RE: Data Adequacy Supplement
San Francisco Electric Reliability Project (04-AFC-1)

SAN FRANCISCO ELECTRIC RELIABILITY PROJECT DATA ADEQUACY SUPPLEMENT (04-AFC-1)

Submitted by:
City and County of San Francisco

FIGURE 8.10-3R
EXISTING (2000) AM AND PM
PEAK HOUR VOLUMES,
INTERSECTION CHANNELIZATION
AND TRAFFIC CONTROL
 SAN FRANCISCO ELECTRIC RELIABILITY PROJECT
CH2MHILL

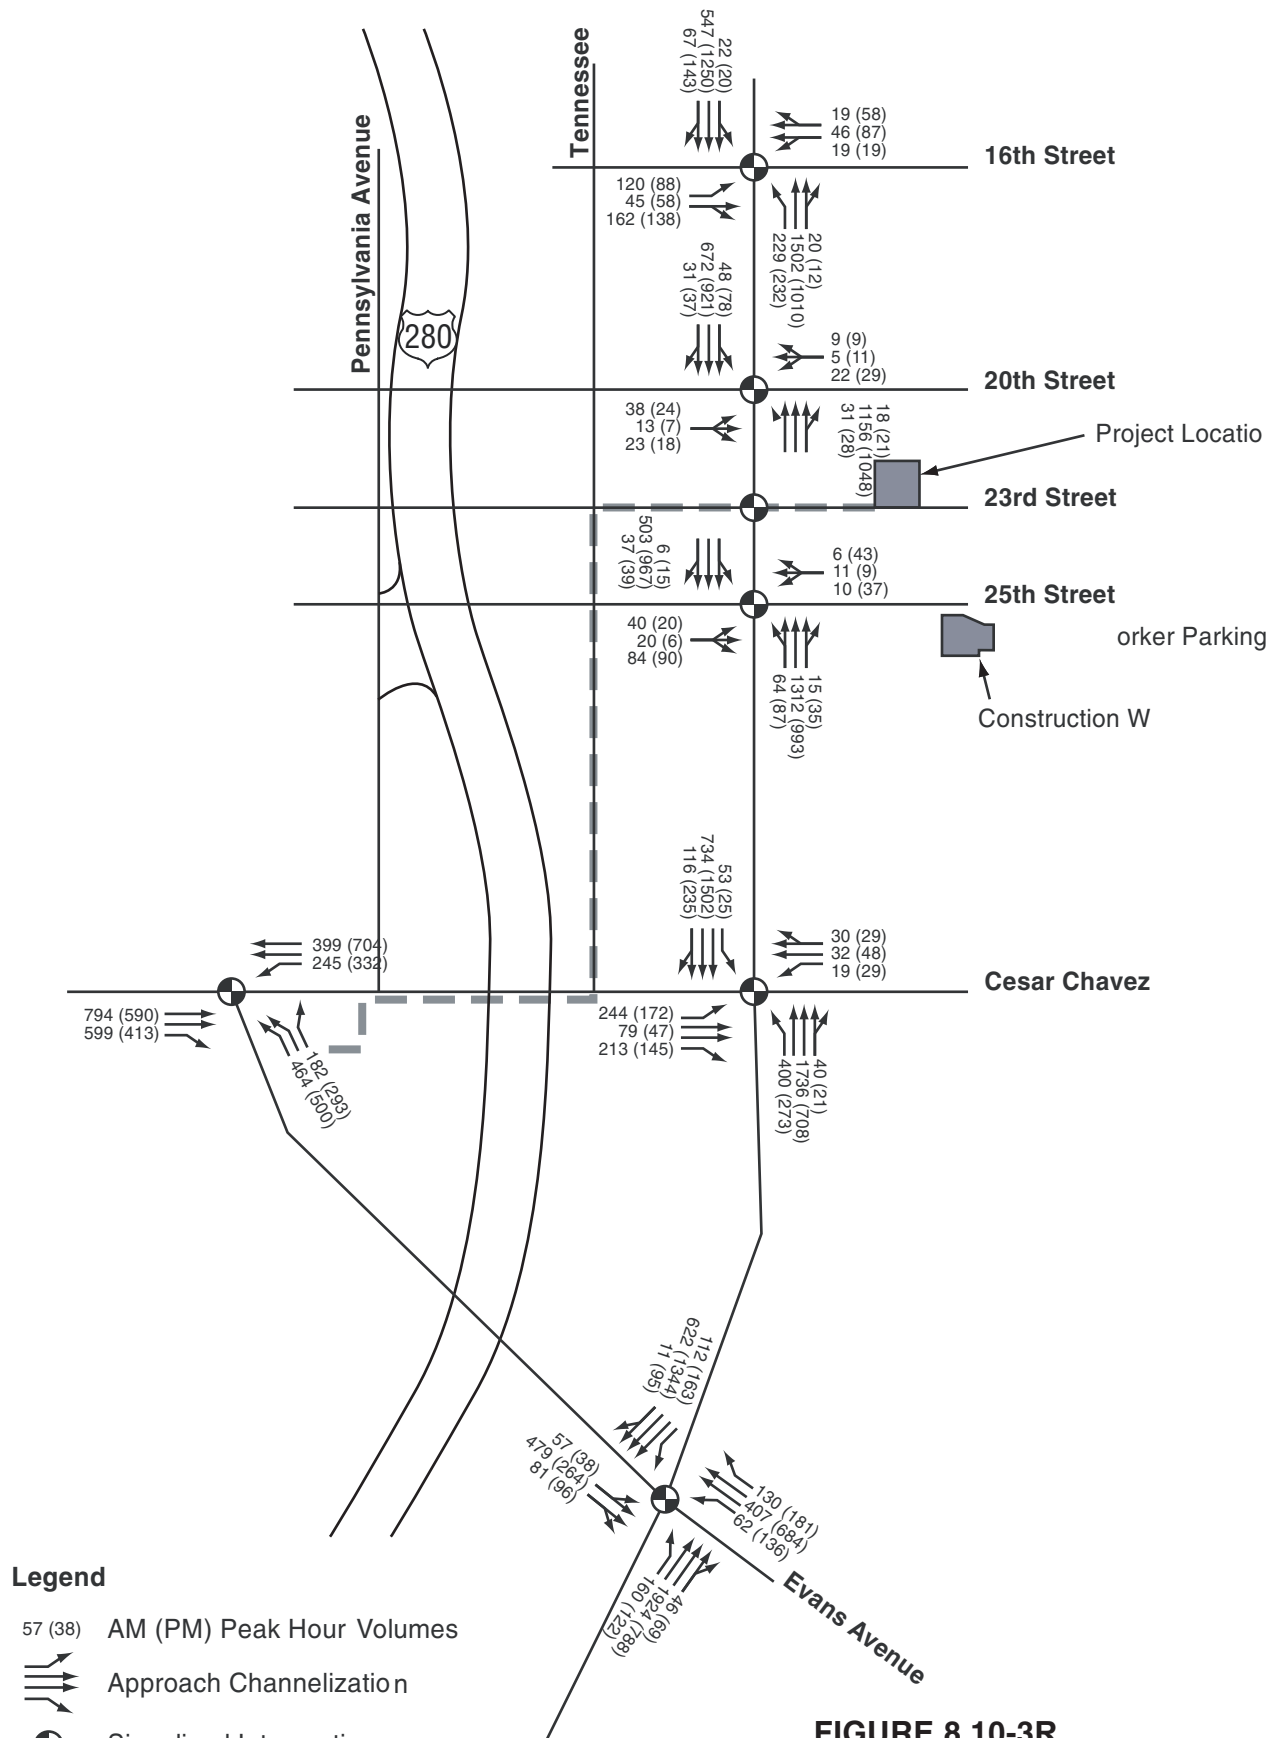
Data Adequacy Deficiency – Please include the Third Street Light Rail Line and planned Light Rail extension in Figure 8.10-2. Appendix B(g)(5)(B).

Data Adequacy Response – See revised subsection 8.10R, attached.

8.10.2.3.1 Existing Conditions. Figure 8.10-3R illustrates the existing a.m. and p.m. peak hour traffic volumes, intersection geometrics and controls, while Table 8.10-4 shows the results of the existing condition traffic analysis. Under existing conditions, the studied intersections operate at LOS D or better for both the a.m. and p.m. peak periods. The intersections within proximity to the project, Third Street/20th Street and Third Street/25th Street currently operate at LOS A and LOS B during the a.m. and p.m. peak hours, respectively. The intersection of Third Street/Evans Avenue operates at LOS D (37.3 seconds delay) during the a.m. peak hour.
